January 16, 2020
BOARD OF COUNTY COMMISSIONERS
ORANGE COUNTY, FLORIDA
ADDENDUM NO. 2 / IFB Y20-729-RM
ORANGE COUNTY INTERNAL OPERATIONS CENTER I RESTROOMS RENOVATIONS
REVISED BID OPENING DATE: January 23, 2020

Project:
INTERNAL OPERATIONS CENTER - I
RESTROOM UPGRADES - ALL FLOORS
450 E. SOUTH STREET
ORLANDO, FL 32801

Sheet Title:
ENLARGED FLOOR PLAN
& ELEVATIONS

7 RESTROOM PARTITION HANGER BRACING RETROFIT DETAIL
SCALE: N.T.S.

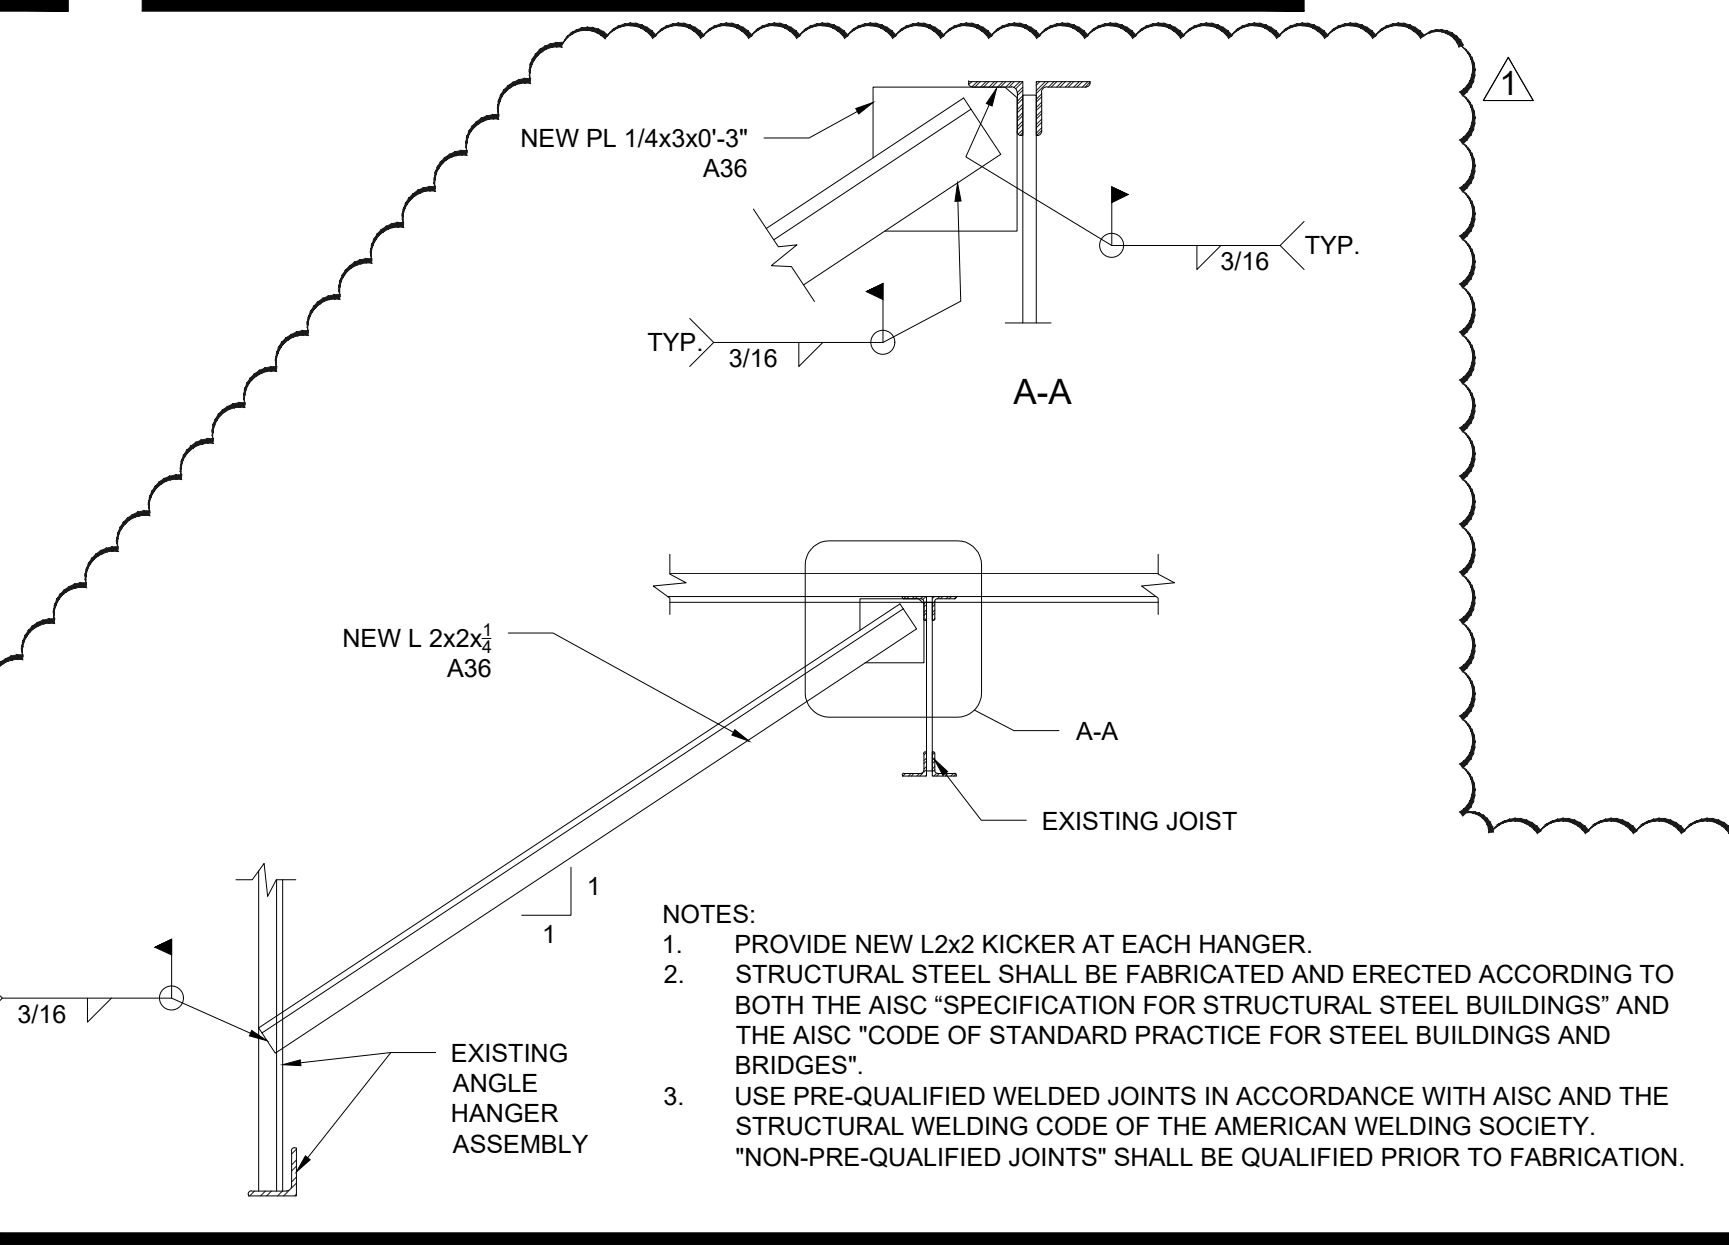
4. **Note: One manufacturer (Scranton Products) says the solid plastic partitions are too heavy to be ceiling mounted. Current partitions are made of laminate.**

- 26. Toilet Partitions: New ceiling mounted partitions are planned. Do we need to provide any additional floor mounted supports similar to existing partitions, or ceiling mounted only with no floor bracing?**

31. At the site visit, a contractor noted that the plans call for ceiling-hung HDPE toilet partitions, which is typically not provided by partition manufacturers. One of the Orange County representatives mentioned that a manufacturer (Scranton Products) had visited the site and determined that they will be able to meet their warranty requirements for ceiling-hung HDPE partitions. Will the contact information for the Scranton Products representative be made available?

Structural Engineer verified existing condition and confirmed the weight of the new ceiling mounted partitions could be supported by the existing structure. A revised drawing will be provided with a detail for supplementary steel required.

Install new ceiling mounted partitions with no floor support. A revised drawing will be provided with a detail for supplementary steel required.

Correction. The Scranton Products information came from a previous similar project completed in another building where Scranton Products were utilized as ceiling hung partitions. See revised drawing supplied with this addendum showing additional steel requirements for the new ceiling hung partitions.
